Access Compliance Report

Public Rights-of-Way

(Curb Ramps)

Intersection ID: 46817	Main Street: ARBOR_VISTA_DR	Cross Street: HOLM_OAK_PL	Location: NE
ADA ID: 6BD74B8E8EBB	Ramp Type: PerpDiag	Initial Pass/Fail: Fail	Overall Compliance: No
		Severity Score: 30

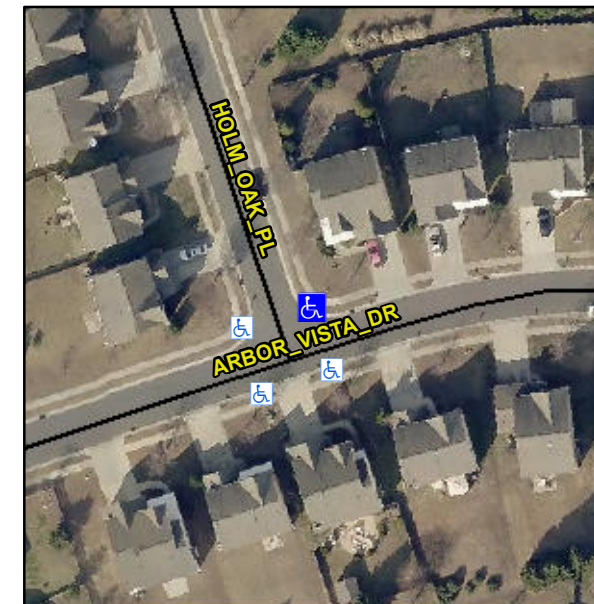
Not Found, R304.5.1, R304.2.2

Remove & Replace Curb Ramp With Two New Directional Ramps or Equivalent.
